NAUTICAL POINTE SUBDIVISION

APPLICATION NUMBER 20 DATE January 3, 2008

REQUEST Subdivision

DETAIL SITE PLAN

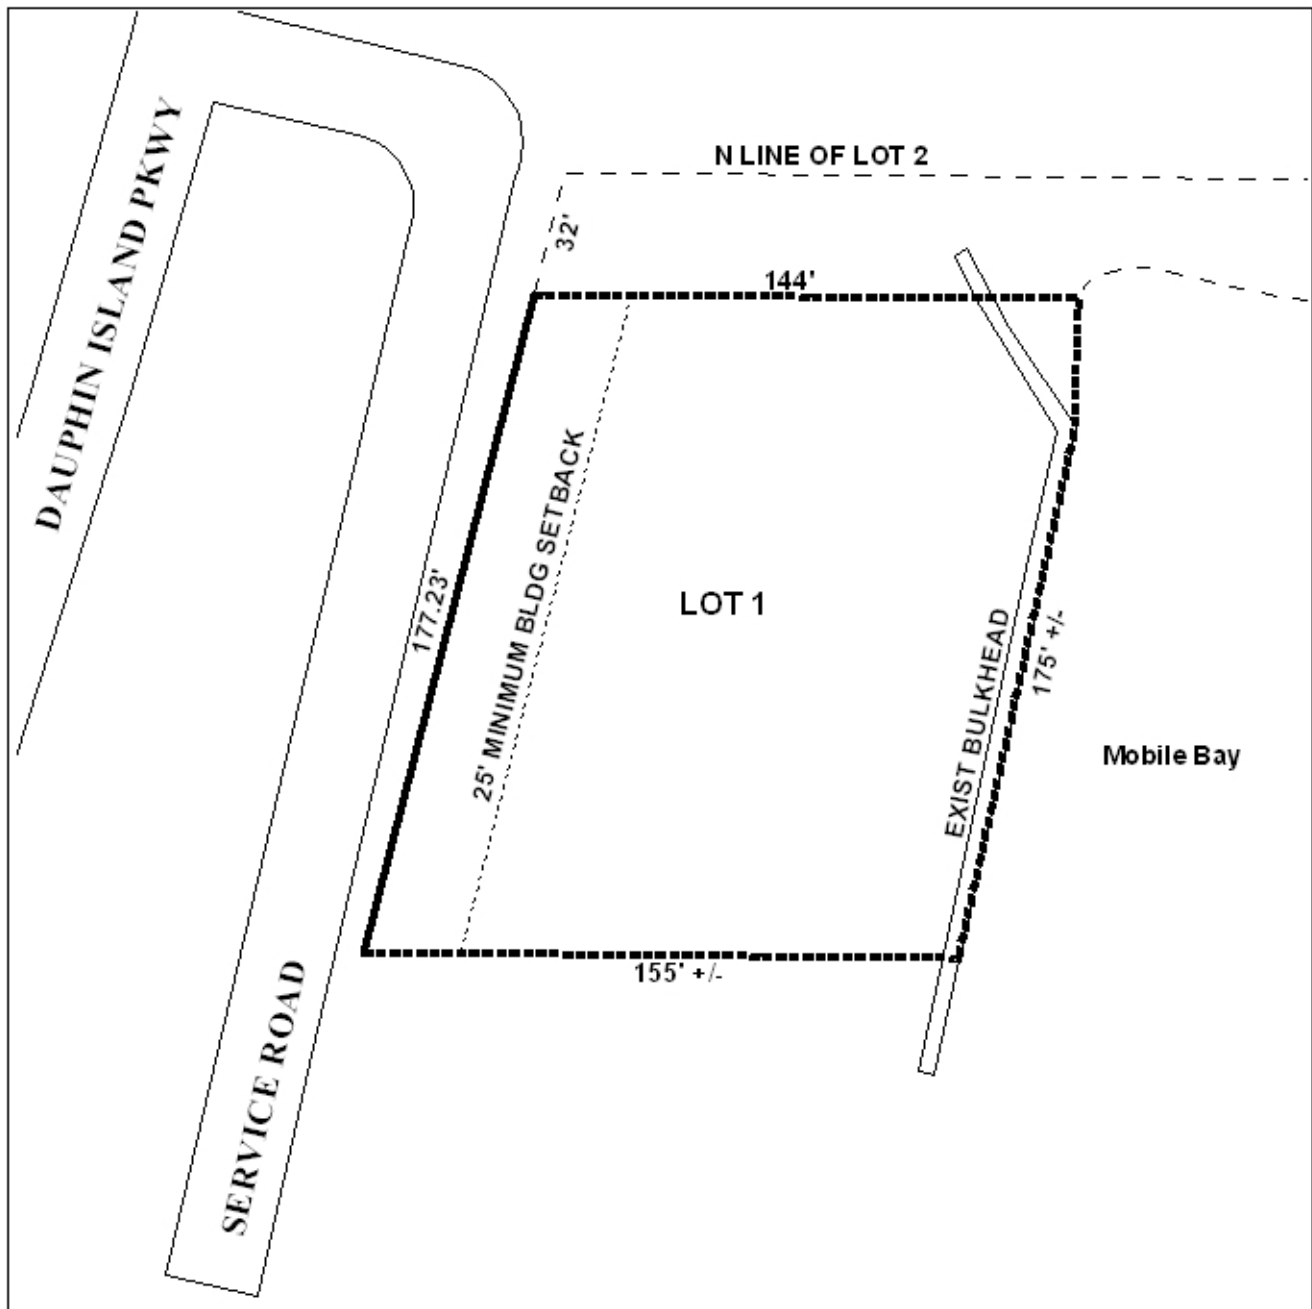
Engineering Comments: Show minimum finished floor elevation on the lot as 12.77' on plat, which is one foot above the Hurricane Katrina high water elevation in the area. No fill or grading allowed in VE zone, per FEMA regulations; add note to the plat to this effect. It is the responsibility of the applicant to look up the site in the City of Mobile (COM) GIS system and verify if NWI wetlands are depicted on the site. If the COM GIS shows wetlands on the site, it is the responsibility of the applicant to confirm or deny the existence of wetlands on-site. If wetlands are present, they should be depicted on plans and/or plat, and no work/disturbance can be performed without a permit from the Corps of Engineers. Must comply with all storm water and flood control ordinances. Any work performed in the right of way will require a right of way permit. No fill or grading allowed in VE zone. Any construction shall be in compliance with all FEMA guidelines.

The site was approved for a one lot subdivision in 2005 and extended in 2006; but it expired in August 2007, hence this application. However the legal description has changed since the last application to exclude 32' along the service road at the Northern part of the proposed lot. The total excluded portion of the lot is approximately 4600 square feet. It is recommended that the plat be revised to include the remainder of the metes and bounds parcel in the subdivision process.

Due to the width of the lot fronting onto the service road, the site should be limited to a maximum of two curb-cuts, with the size, location and design to be approved by Traffic Engineering and conform to AASHTO standards. Furthermore, as Dauphin Island Parkway is a state highway, review of the access by the Alabama Department of Transportation may be required.

The plat meets the minimum size requirement for developments with access to public water and sewer. However, it is requested that the applicant revise the preliminary plat to label the lot with its size in square feet, or provide a table on the plat with the same information.

- 1) placement of a note on the final plat stating that the lot is limited to two curb cuts to Dauphin Island Parkway service road, with the size, location, and design to be approved by City of Mobile Traffic Engineering, Alabama Department of Transportation, and conform to AASHTO standards;*
- 2) the applicant receive the approval of all applicable federal, state and local environmental agencies prior to the issuance of any permits;*
- 3) labeling of the lot with its size in square feet, or the provision of a table on the plat with the same information;*
- 4) placement of a note on the plat / site plan stating that the site will be developed in compliance with all local, state and Federal regulations regarding endangered, threatened or otherwise protected species; and*

- 5) *Subject to Engineering comments:* Show minimum finished floor elevation on the lot as 12.77' on plat, which is one foot above the Hurricane Katrina high water elevation in the area. No fill or grading allowed in VE zone, per FEMA regulations; add note to the plat to this effect. It is the responsibility of the applicant to look up the site in the City of Mobile (COM) GIS system and verify if NWI wetlands are depicted on the site. If the COM GIS shows wetlands on the site, it is the responsibility of the applicant to confirm or deny the existence of wetlands on-site. If wetlands are present, they should be depicted on plans and/or plat, and no work/disturbance can be performed without a permit from the Corps of Engineers. Must comply with all storm water and flood control ordinances. Any work performed in the right of way will require a right of way permit. No fill or grading allowed in VE zone. Any construction shall be in compliance with all FEMA guidelines.
